COMMONWEALTH OF KENTUCKY
BEFORE THE PUBLIC SERVICE COMMISSION

APPLICATION OF KENTUCKY UTILITIES)	
COMPANY FOR A CERTIFICATE OF PUBLIC)	CASE NO: 2017-00483
CONVENIENCE AND NECESSITY AND)	
APPROVAL OF AMENDMENT TO ITS 2016)	
COMPLIANCE PLAN FOR RECOVERY BY)	
ENVIRONMENTAL SURCHARGE)

**RESPONSE TO TECHNICAL NOTICE OF
DEFICIENCY (NOD) No.1
SITEWIDE GROUNDWATER
REMEDIAL ACTION PLAN**

**Subject: Response to Technical Notice of Deficiency (NOD) No.1
Sitewide Groundwater Remedial Action Plan
Kentucky Utilities (KU) - E.W. Brown Generating Station
Burgin, Mercer County, Kentucky
Agency Interest No. 3148
Application ID No. ARM20150001
AMEC Project No. 567530023**

PLATE 2

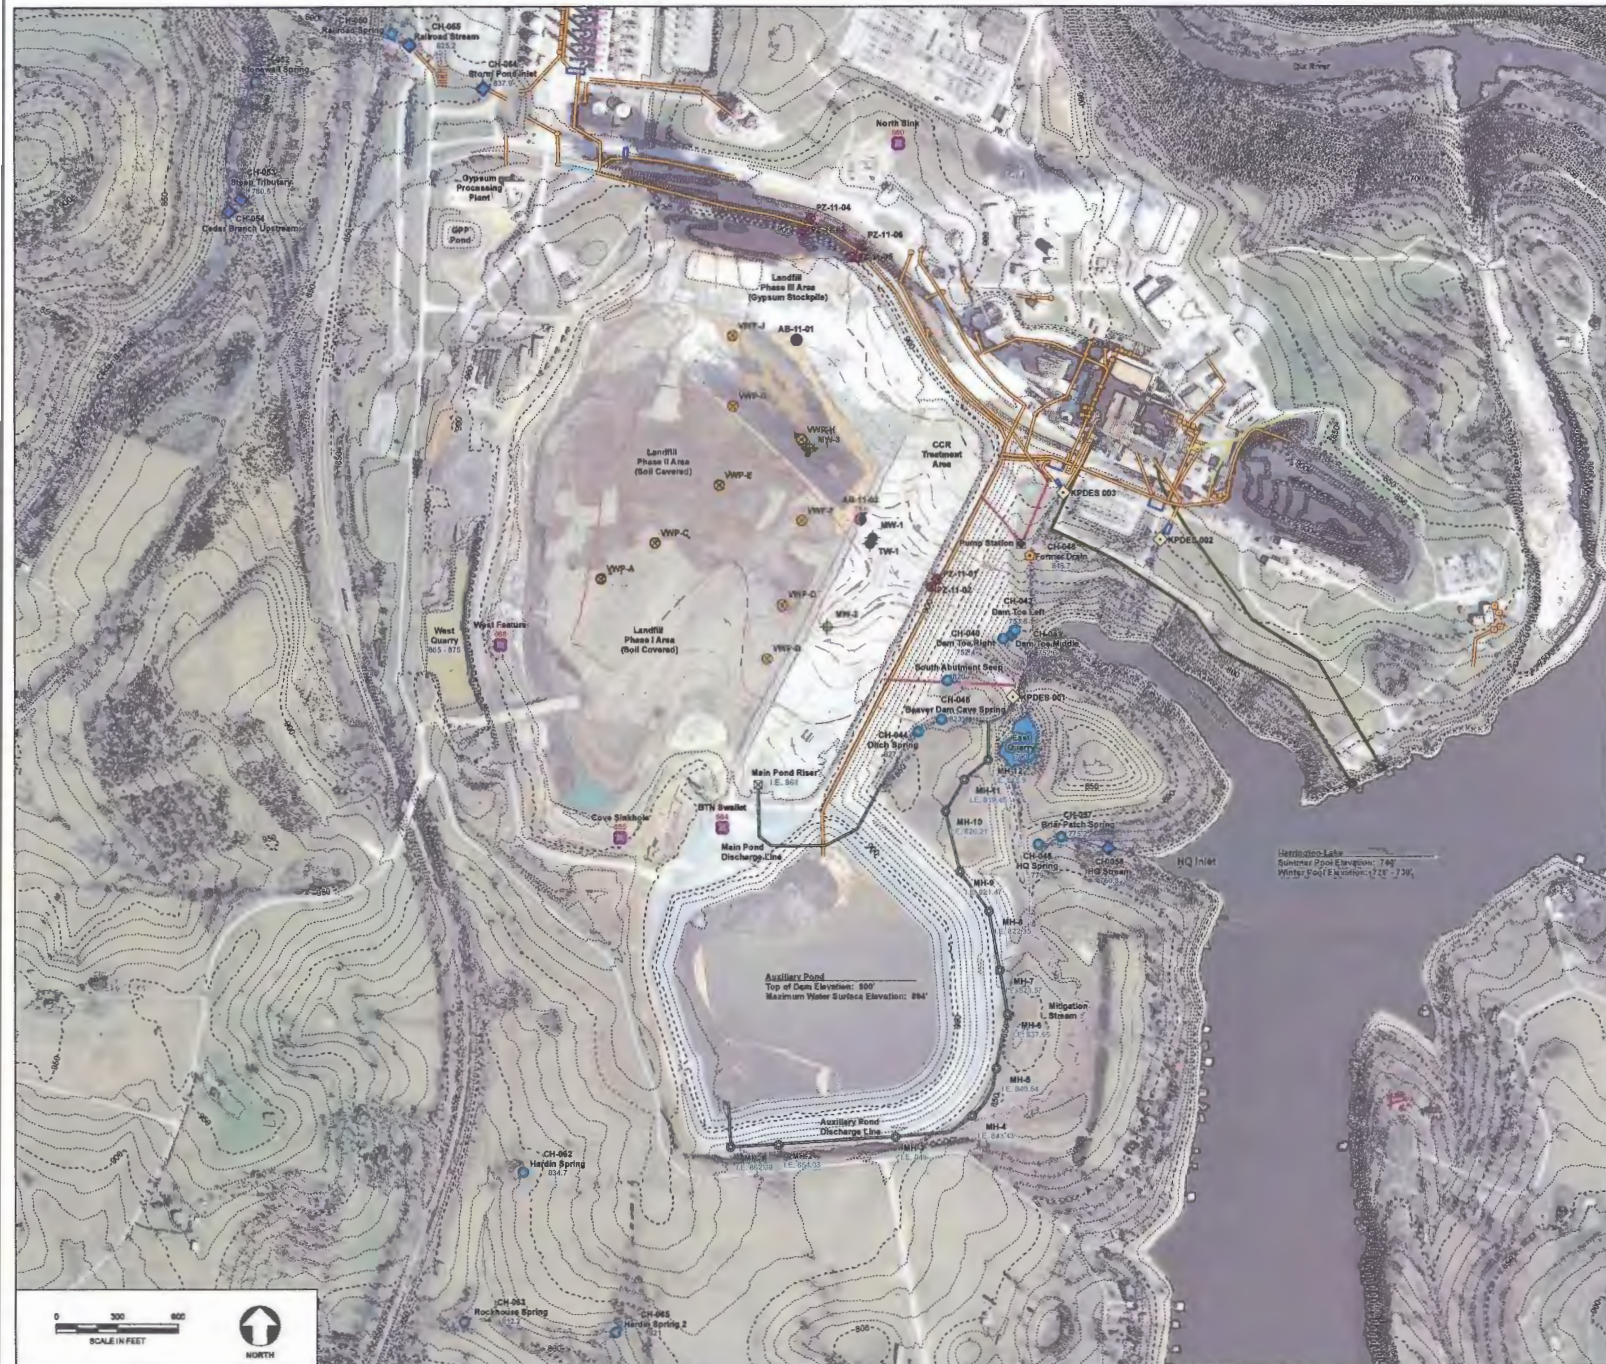
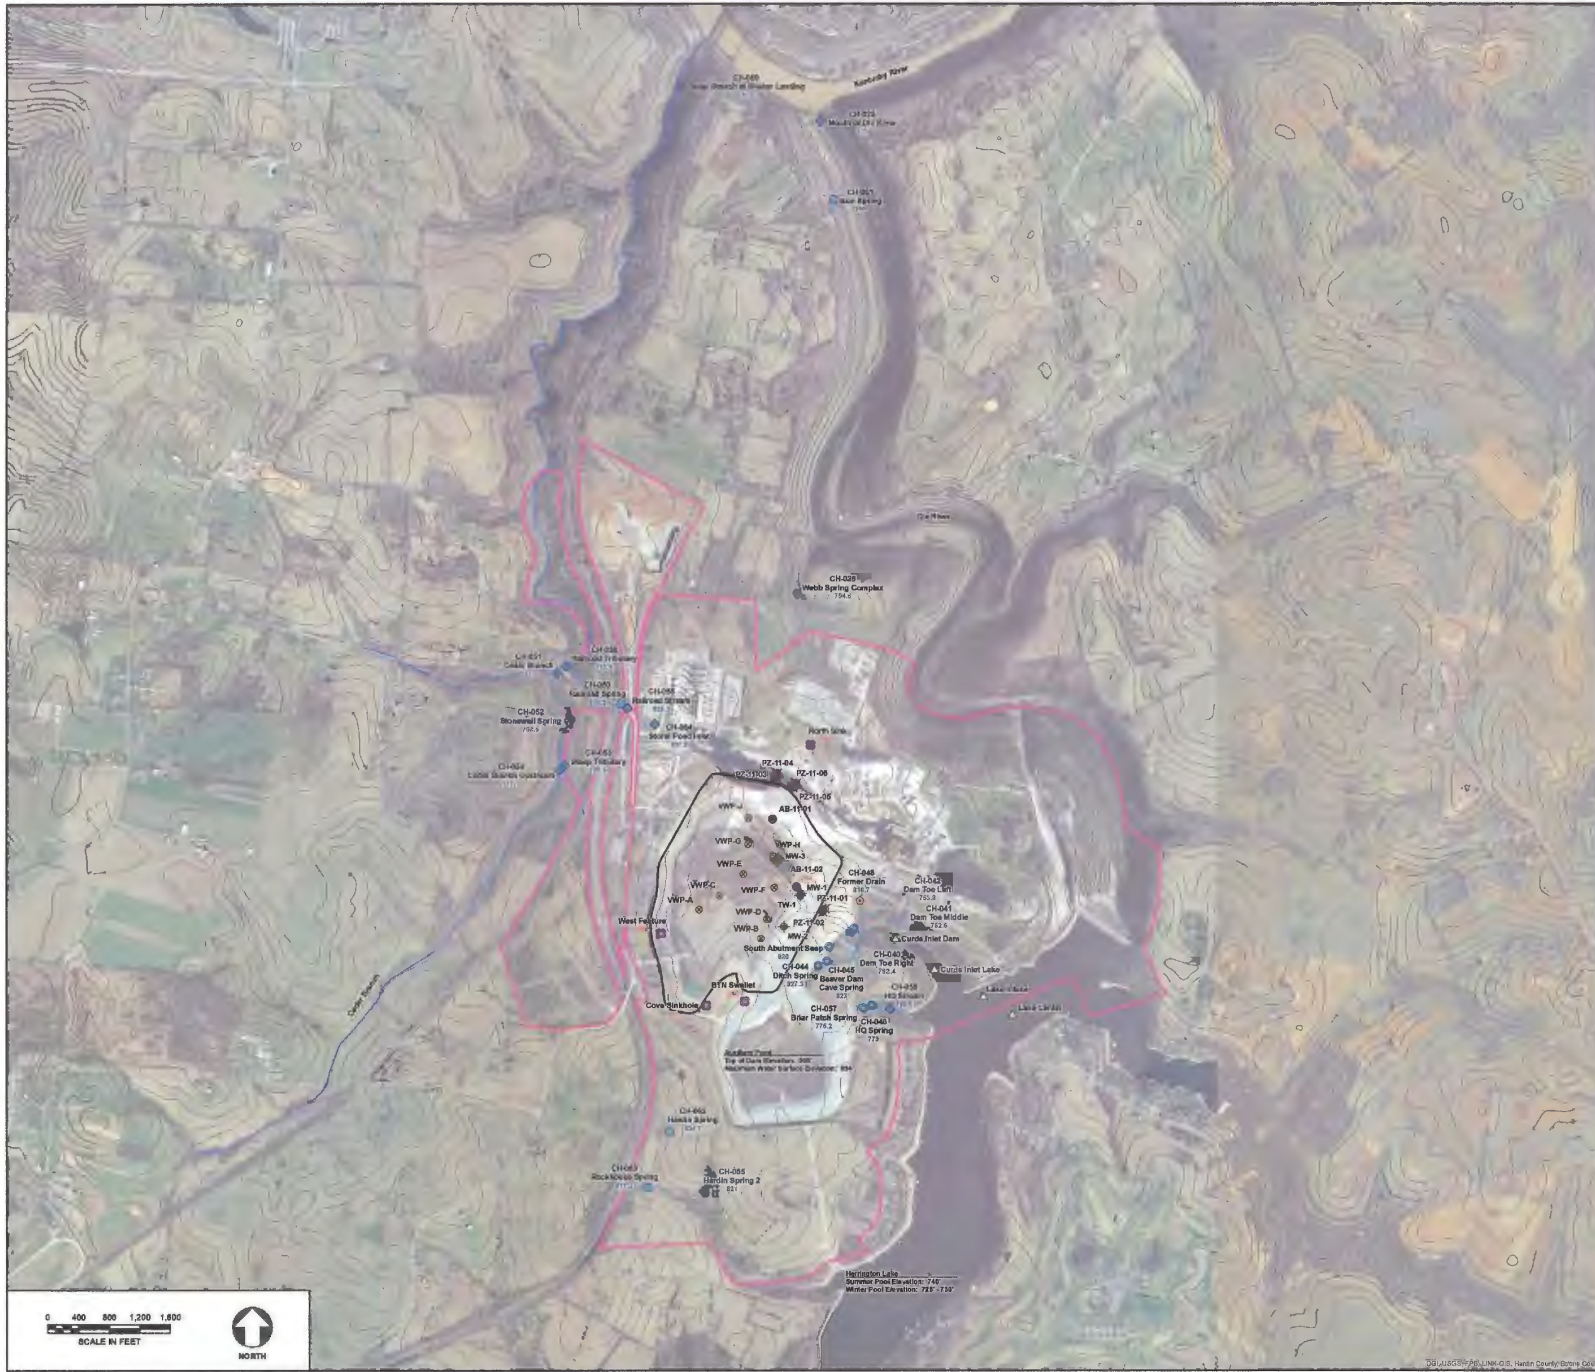
2. *Plan sheets must be signed, sealed, and dated by a professional engineer licensed in the Commonwealth of Kentucky pursuant to KRS 322.*

The attached copies of the Plates (Plates 1 and 2) and the plan sheets in Appendices A, B, and C have been signed, sealed and dated by a Professional Engineer licensed in Kentucky. They are provided in Attachment 2.
